**PETITION NO:** Z-19

# Z-19

### **Z-19 THE PACIFIC GROUP, INC.**

Re: Application of The Pacific Group, Inc. to Rezone an 11.49 Acre Tract from  
FST to RA-5 (No. Z-19)

LAND LOTS 24, 25 & 26  
30TH DISTRICT - 2ND SECTION  
COBB COUNTY, GEORGIA  
SCALE 1"=100' / NOVEMBER 9 2004

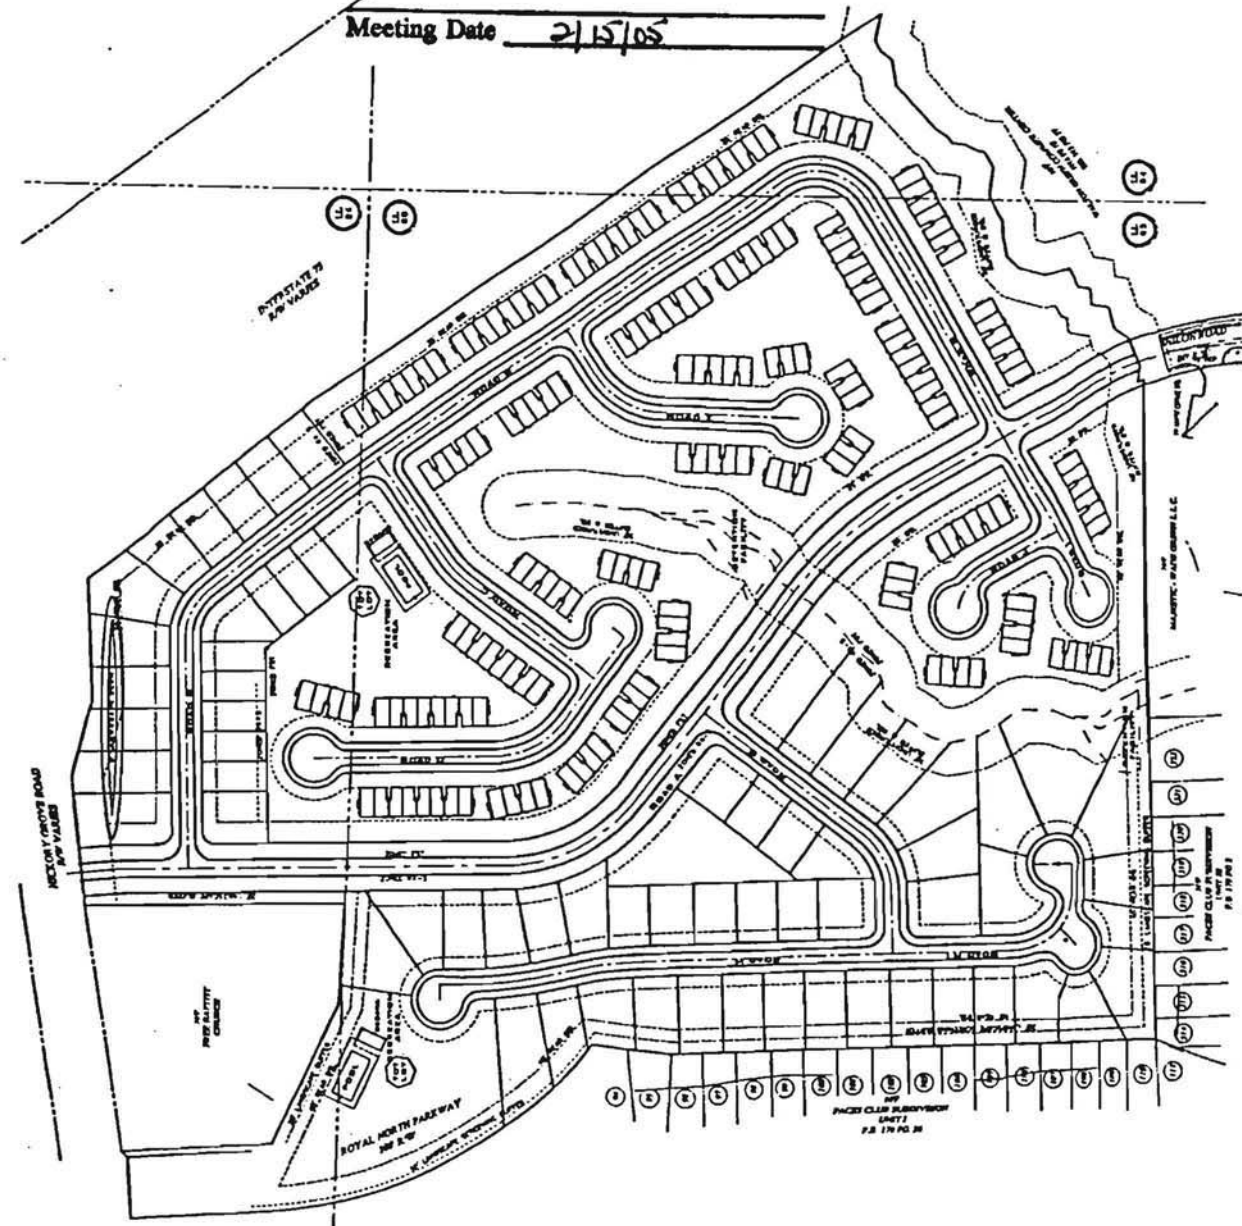
Revised Plan submitted via December 29, 2004 transmittal over hand of Garvis L. Sams, Jr., Esq. Due to aggressive terrain, engineering problems were anticipated in the Stormwater Management Zoning Comments for this project. The reduction in density is a move in correct direction to reduce impact.
